VIRGINIA ELECTRIC AND POWER COMPANY
RICHMOND, VIRGINIA 23261

VIRGINIA ELECTRIC AND POWER COMPANY
SURRY POWER STATION UNITS 1 AND 2
NORTH ANNA POWER STATION UNITS 1 AND 2
GENERIC LETTER 97-01, DEGRADATION OF CRDM/CEDM NOZZLE
AND OTHER VESSEL CLOSURE HEAD PENETRATIONS
REQUEST FOR ADDITIONAL INFORMATION (RAI)

Virginia Power Response to:
NRC Request for Additional Information (RAI) Regarding Utilities Participating in
the Westinghouse Owners Group (WOG) Response to Generic Letter 97-01:
"Background and Methodology for Evaluation of Reactor Vessel Closure Head
Penetration Integrity for the Westinghouse Owners Group"
Topical Report No. WCAP-14901, Rev. 0

Figure 1. Industry Histogram for Reactor Vessel Head Penetration Nozzle Primary Water Stress Corrosion Cracking (PWSCC)

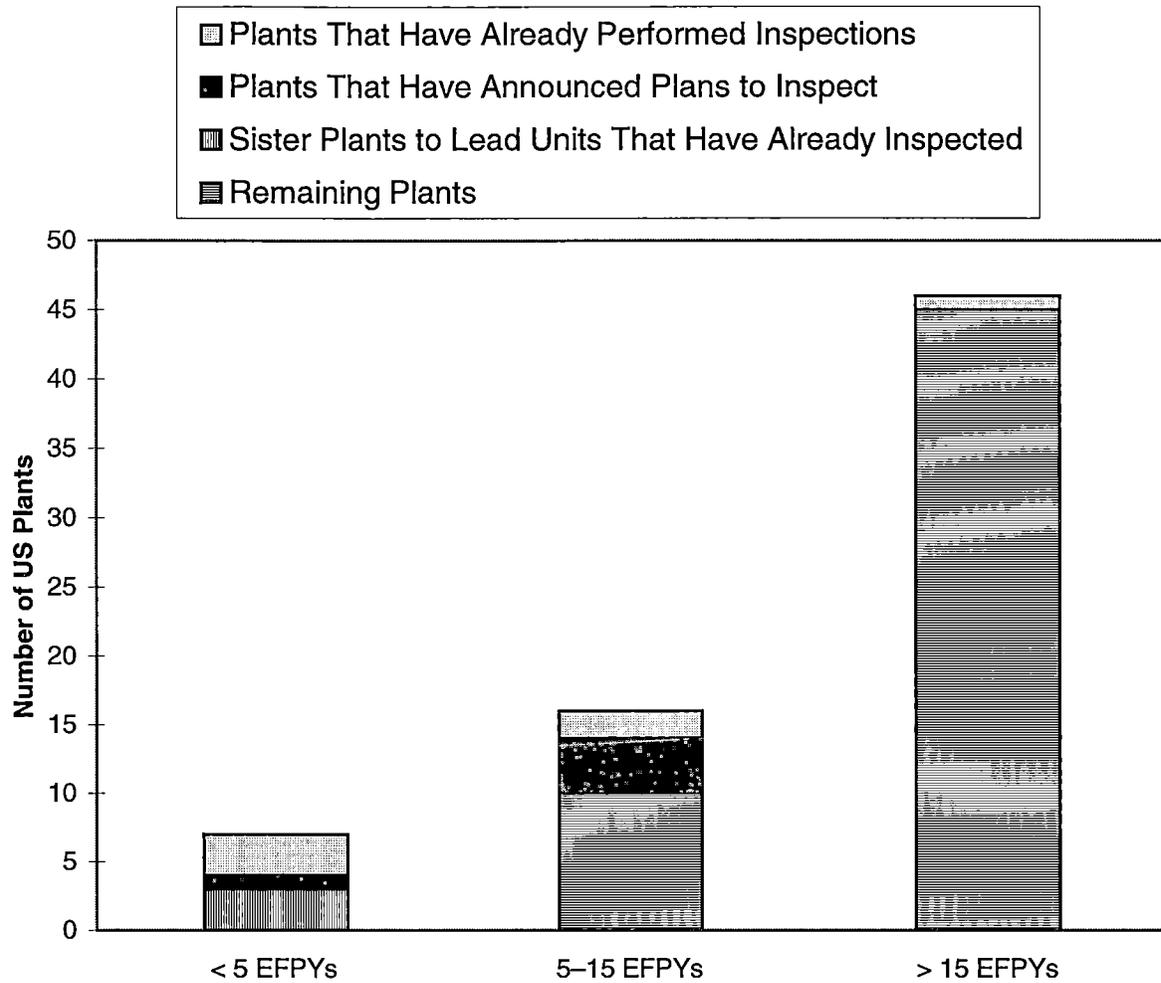
Response to RAI Question #1a: *"Provide the latest model susceptibility ranking of your plant based on the model analysis results, including the basis for establishing the ranking of your plant relative to the ranking of other plants in your owners group analyzed using your model."*

Response to RAI Question #3: *In the NEI letters of January 29, 1998, and April 1, 1998, NEI indicated that inspection plans have been developed for the RVP nozzles at the Farley Unit 2 plant in the year 2002, and the Diablo Canyon Unit 2 plant in the year 2001, respectively. The staff has noted that although you have endorsed the probabilistic susceptibility model described in WCAP-14901, Revision 0, other WOG member licensees have endorsed a probabilistic susceptibility model developed by an alternate vendor of choice. The WOG's proposal to inspect the RVP nozzles at the Farley Unit 2 and Diablo Canyon Unit 2 plants appears to be based on a composite assessment of the RVP nozzles at all WOG member plants. Verify that such a composite ranking assessment has been applied to the evaluation of RVP nozzles at your plant(s). If composite ranking of the RVP nozzles at WOG member plants have been obtained from the composite results of the two models, justify why application of the probabilistic susceptibility model described in WCAP-14901, Revision 0, would yield the same comparable rankings of the RVP nozzle for your plant(s) as would application of the alternate probabilistic model used by the WOG member plants not subscribing to WCAP-14901, Revision 0. Comment on the susceptibility rankings of the RVP nozzles at your plant(s) relative to the susceptibility rankings of the RVP nozzles at the Farley Unit 2 and Diablo Canyon Unit 2 plants.*

For industry planning purposes, plants have been grouped into three categories based on the predicted time to reach the allowable flaw depth limit. These results are provided in the industry histogram provided as Figure 1 of the December 11, 1998 NEI submittal (attached).

North Anna 1 and Surry 1 are grouped in the composite model industry category calculated as most susceptible to reactor vessel head penetration (RVP) cracking, whereas North Anna 2 and Surry 2 reside in the intermediate cracking

The announcement of inspection plans by individual WOG plants is the result of each individual plant's economic situation, along with their future operational plans. The individual plant results are all compared in the histogram in Figure 1. An individual plant's category in the histogram is one of the many considerations which must be evaluated in making inspection decisions.

North Anna 1 and Surry 1 are grouped in the same composite model industry category calculated as most susceptible to RVP cracking as is Farley 2. North Anna 2 and Surry 2 reside in the intermediate cracking susceptibility group with Diablo Canyon 2. However, North Anna 1 already performed limited volumetric inspections in February 1996 at the most susceptible locations and found no cracks. Moreover, as summarized earlier in Virginia Power's initial response to GL 97-01 (Serial No. 97-214A), WCAP-14552 (a plant specific RVP analysis at North Anna and Surry) showed that cracking at all four Virginia Power units should not lead to leaks. That is, the driving force for RVP cracking propagation drops to zero before through wall cracks can extend above the RVP partial penetration weld, the pressure boundary.
